SUBJECT: ASSESSMENT OF THE OYSTER CREEK 3-D FINITE ELEMENT ANALYSIS OF THE DRYWELL SHELL

Docket No. 50-219

STAFF ASSESSMENT OF THE OYSTER CREEK 3-D FINITE ELEMENT ANALYSIS OF THE DRYWELL SHELL

FIGURE 2 Schematic - Sand Bed Area

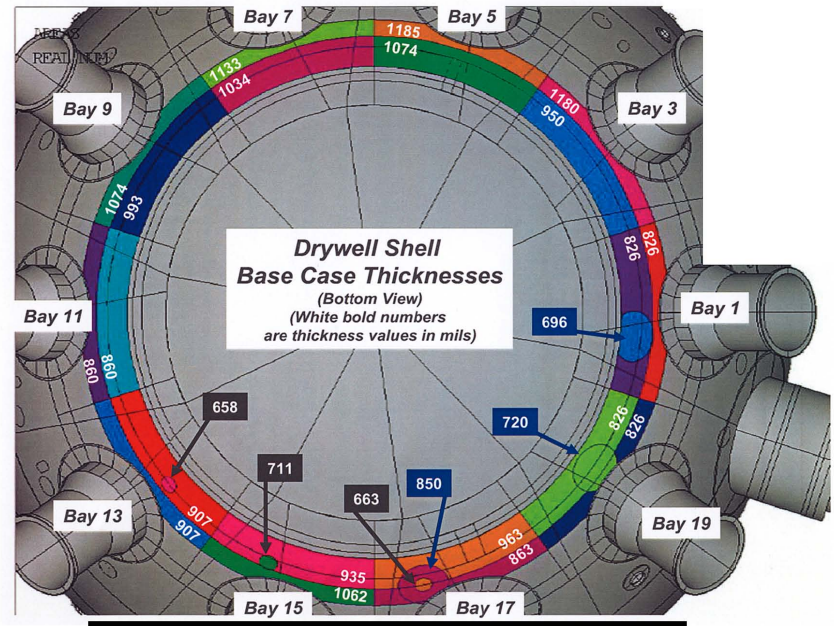
> **Case 1 ("S1"):** Reduce the wall thickness of the defined locally thinned area in Bay 1 from 696 mils (see Figure 2) to 596 mils, keeping the general area of the thickness in Bay 1 constant (826 mils - as in 403R) with all other inputs the same as in the Base Case.
>
> **Case 2 ("S2"):** Reduce the wall thickness of the general area in Bay 19 from 826 mils (see Figure 2) to 776 mils, keeping the thickness of the locally thinned area constant (720 mils) and all other inputs the same as in the Base Case.

To capture the potential uncertainties in identifying the location and degradation of the locally thinned areas, the applicant has reduced the thickness of the 51-inch diameter circle (see Figure 2) by 100 mils in Bay 1, the bay most affected by corrosion. As the UT measurements at certain elevations are not available in certain bays, in addition to the approach taken by the applicant in the Baseline analysis, the applicant has reduced the shell thickness by 50 mils in Bay 19 in S2. This will quantify of the effects of thickness reduction in the sandbed region on the buckling safety factors. The staff finds the use of these sensitivity cases conservative and acceptable for considering the effect of the size and thickness of degraded areas on the available margin.
